**MAJOR DEVELOPMENT ASSESSMENT  
PROJECT APPLICATION FOR MIXED USE  
DEVELOPMENT**

**33 Cross Street, Double Bay**

**Proposed by ASHINGTON MANAGEMENT  
PTY LTD,  
MP08\_0100**

Director-General's Environmental Assessment Report  
Section 75I of the  
*Environmental Planning and Assessment Act 1979*

Diagram 9 - Building Height Study detailing the distribution of buildings greater than 6 storeys in height in relation to the extent of the main Double Bay valley floor (in BLUE)

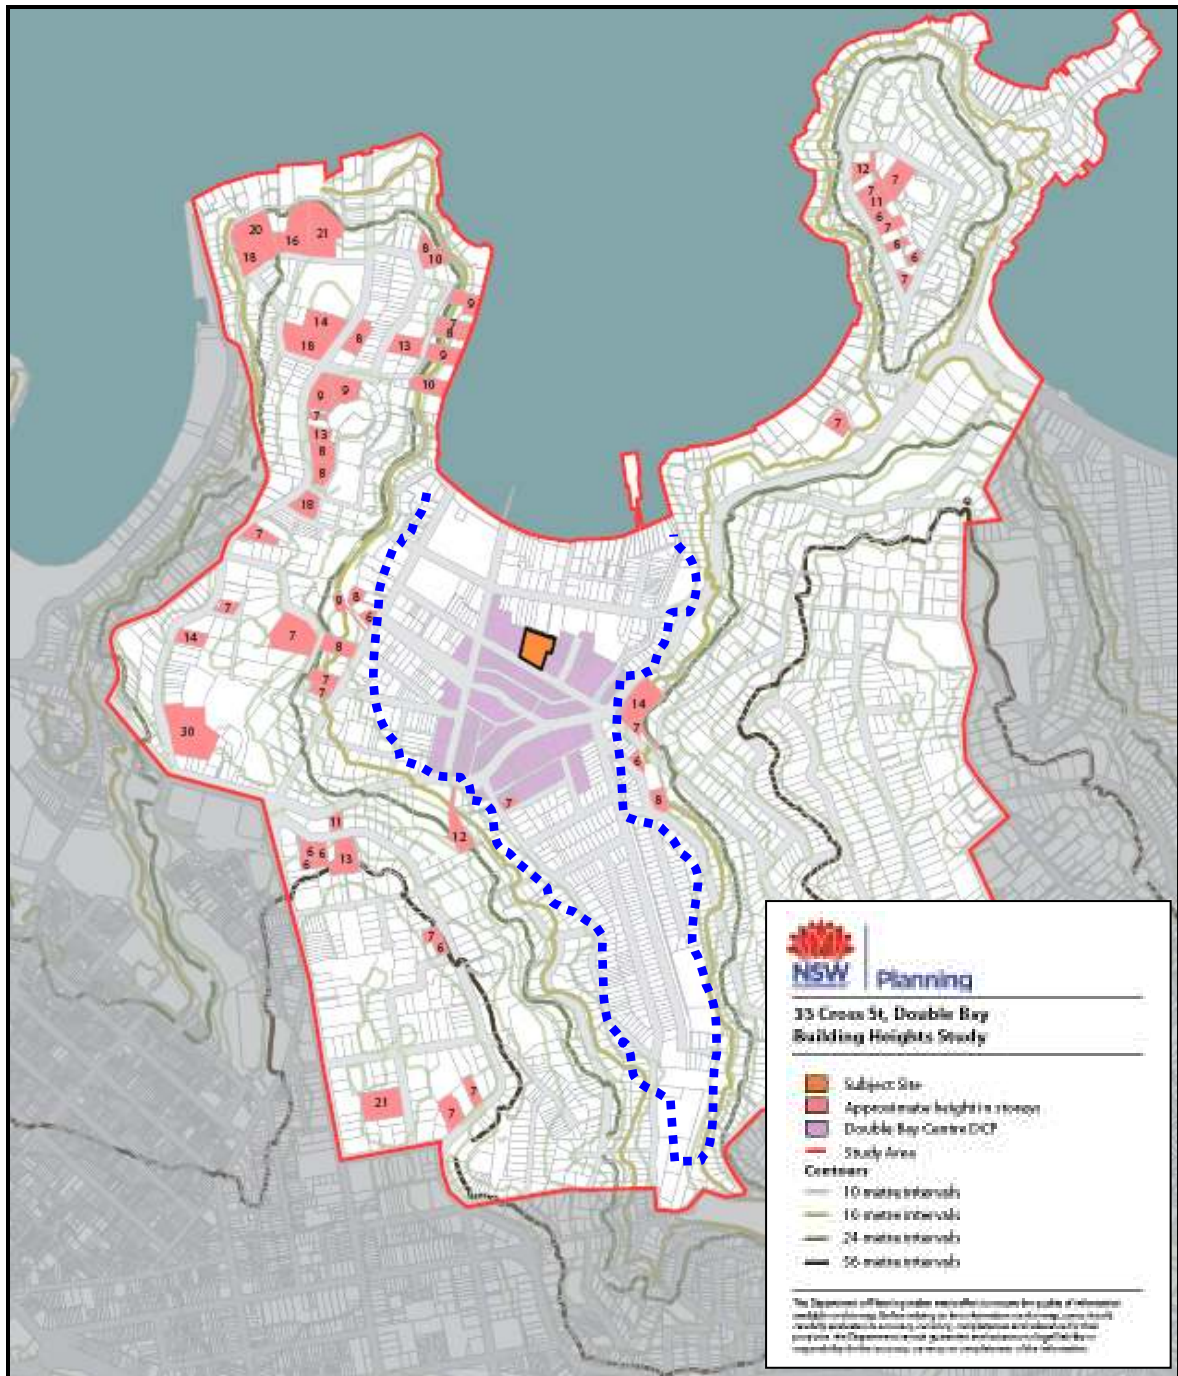
The Department undertook a separate Building Height Study to assess the distribution of buildings greater than 6 storeys in height (**Diagram 9 below**). This study reveals that most large scale buildings are located along the ridges, while the height and scale of built form in the Double Bay valley is more modest and of consistently lower scale.

Diagram 11 - Double Bay locality long sections including proposal (RED arrow) (Source: PPR dated August 2009)

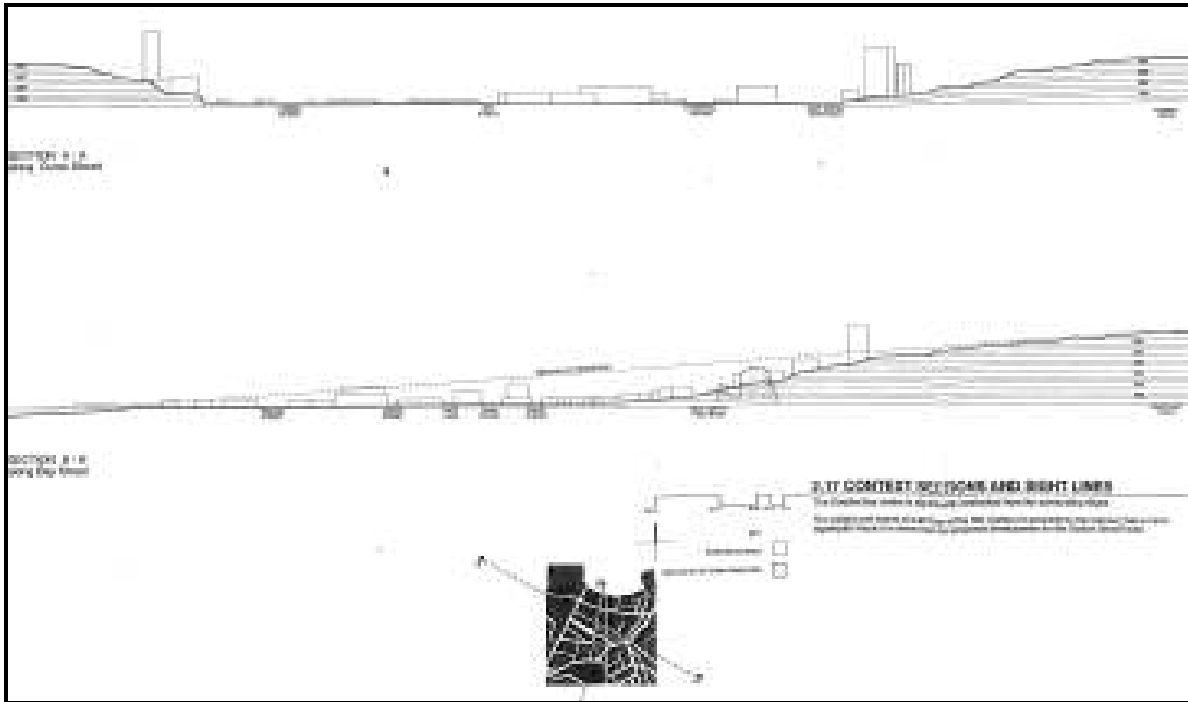
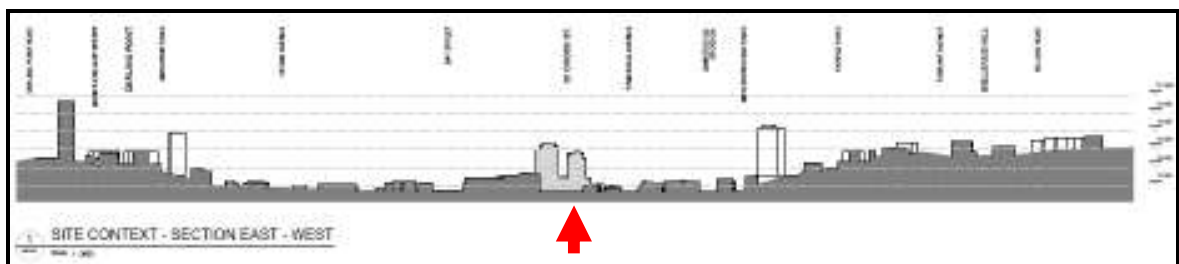
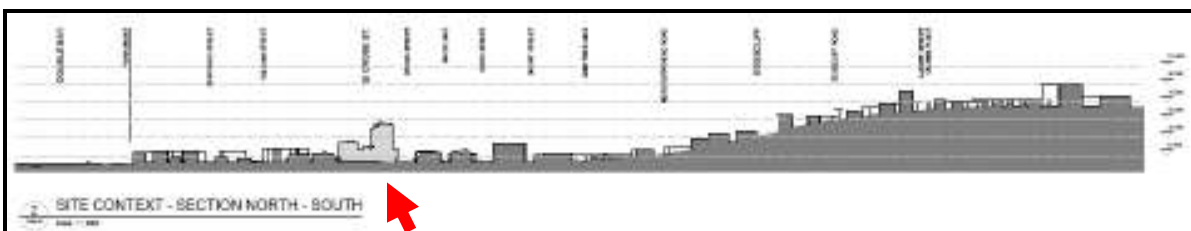
The Government Architect has also identified that the existing mature tree canopy prevalent across the valley floor is a dominant feature and emphasises that there a few circumstances were existing built form extends above the height of that canopy within the valley floor. This relationship is markedly different in respect to the larger scale built form on the adjacent ridges which dominates the landscape (**Diagrams 10-12**).

The Department supports the conclusion that the location of the Double Bay Centre within the valley floor creates a degree of sensitivity with respect to the impacts from larger scale tower forms. Historically, the Double Bay Centre has developed with restrained building heights across the valley floor and this is one of the attributes that gives the Centre its village character.

Diagram 18 - Montage image from Edgecliff Road (View 6) (Source: PPR dated August 2009)

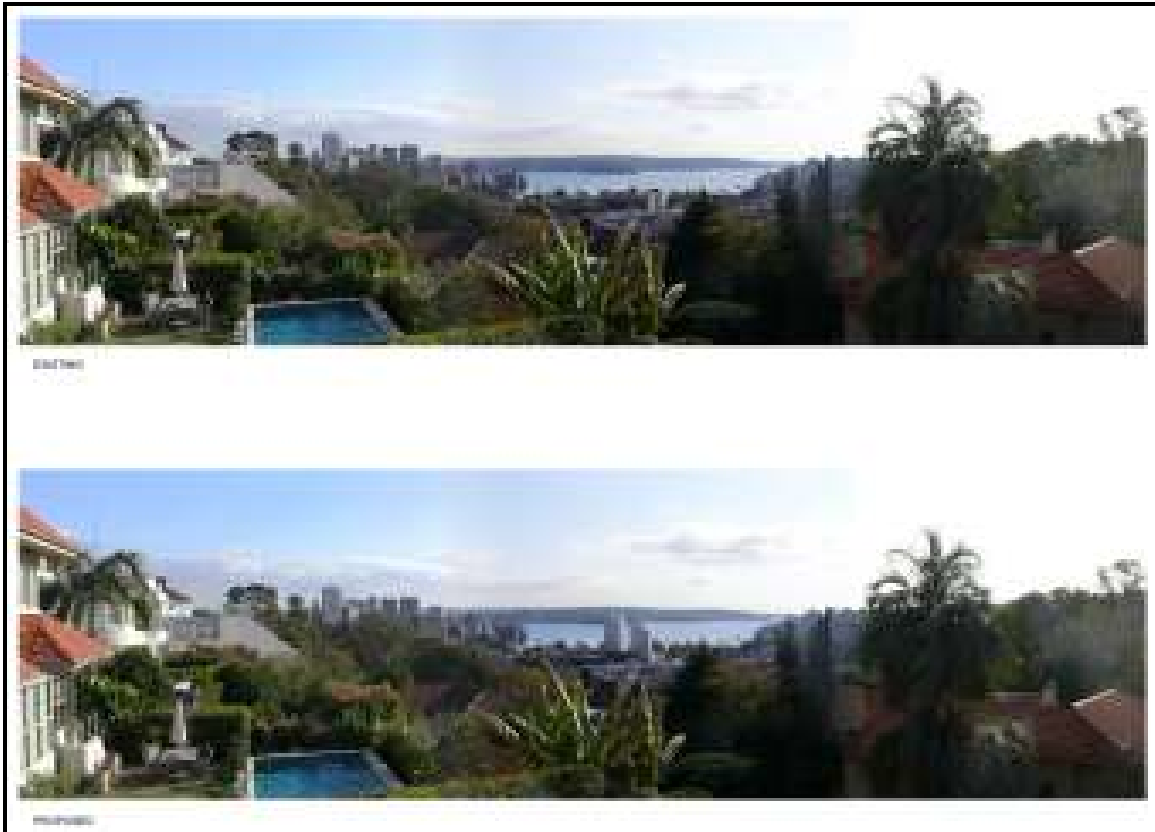
There are certainly a number of vantage points where the towers are expressed above foreground and background, but where this does occur, the impact is generally lesser than that evident from the immediate and local visual catchments as described above, as the tower forms are less prominent in the wider visual catchment.

In this regard, the wider context impacts are generally considered acceptable.

Diagram 20: Piazza open and covered areas

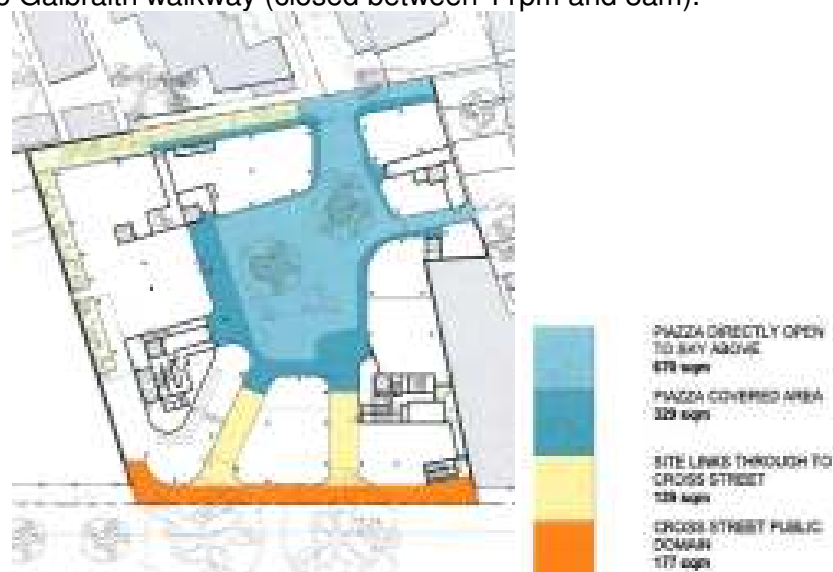
The proposal as depicted in the PPR comprises a central 'open air' piazza of 670m<sup>2</sup> (**Diagram 20**) surrounded by ground floor retail and hotel uses. The piazza will be publicly accessible through a series of ground floor pedestrian connections, with the northern connection to Galbraith walkway (closed between 11pm and 8am).

The Department agrees that the piazza and anticipated retail shops, cafes and restaurant that surround the piazza will be an improvement on the existing ground floor environment. Although the piazza will receive access to natural ventilation, the northern podium elements ensures that in winter the piazza remains largely in shadow. This will require some modification to any podium for this site.

Diagram22: Heritage Map – WLEP 1995

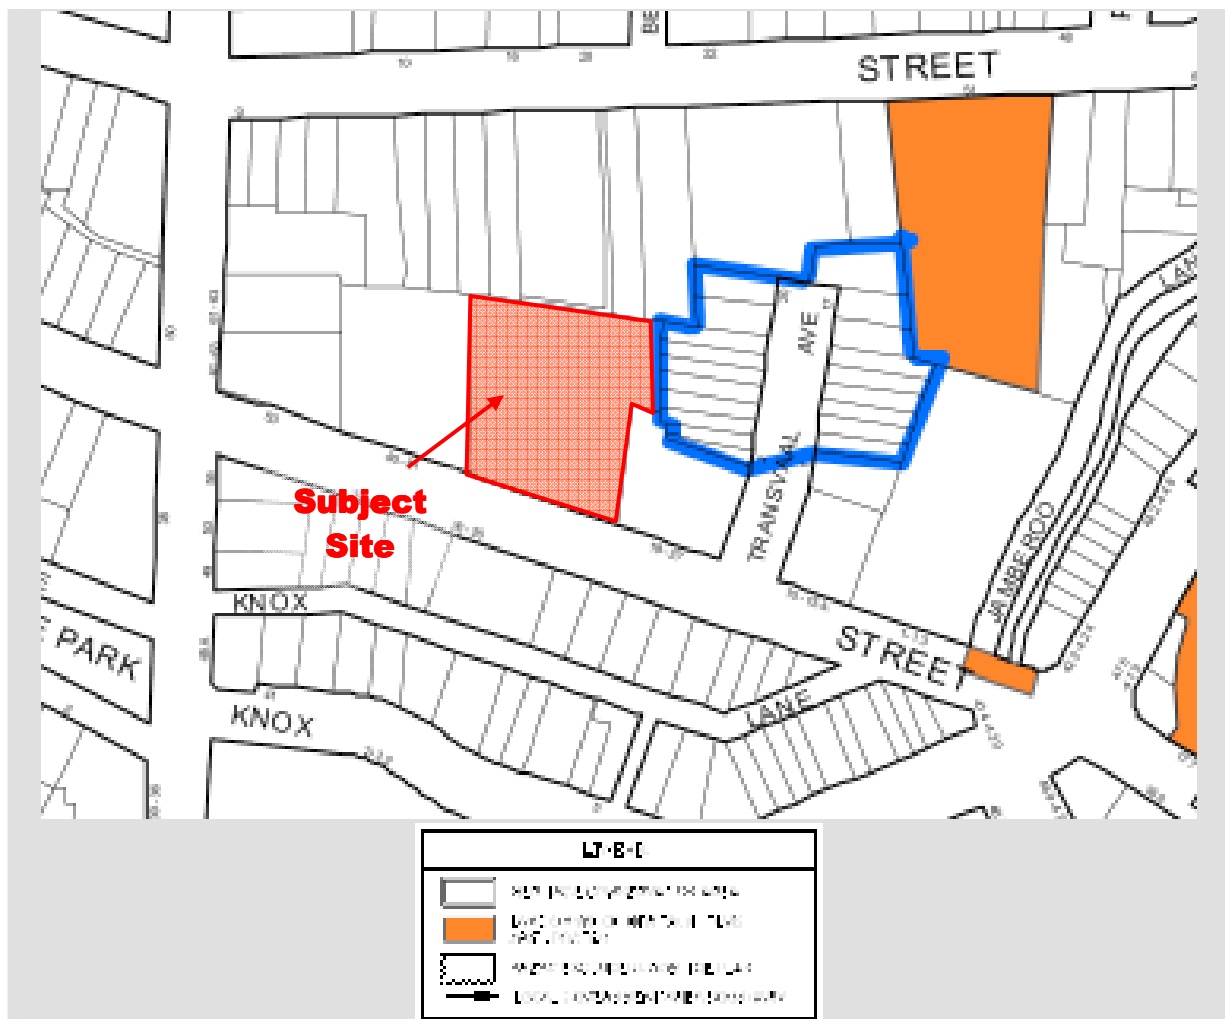
The proposal adjoins the Transvaal Avenue Conservation Area, as shown in Diagram 22.

The PPR design expresses a well resolved palette of materials, finishes and colours within an appropriately articulated podium form. Overall, it features a contemporary architectural language which complements the traditional materials and building features of development in the conservation area. However, the height and scale of the towers are imposing and
